SERVICE 		2
		B0400016

## SB, 334 T, 336, 338 XPT, 339 XP, 357 XP, 335 XPT California, 338 XPT California, Autodecompression valve, 2004-01

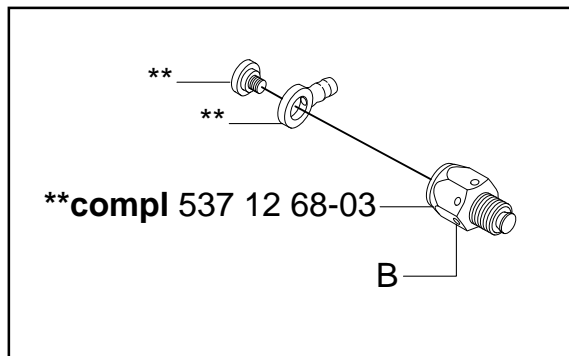
There are two different types of decompression valve. The difference between them is in the spring pressure.

Models 357XP, 335XPT California and 338XPT California have a valve with a high spring pressure (1.8N) marked with a B or AB, see diagram below. The part number that will be used is 537 12 68-03.

Models 334T, 336, 338XPT and 339XP have a valve with a low spring pressure (0.9N) marked with an A. The part number that will be used is 537 12 68-04.
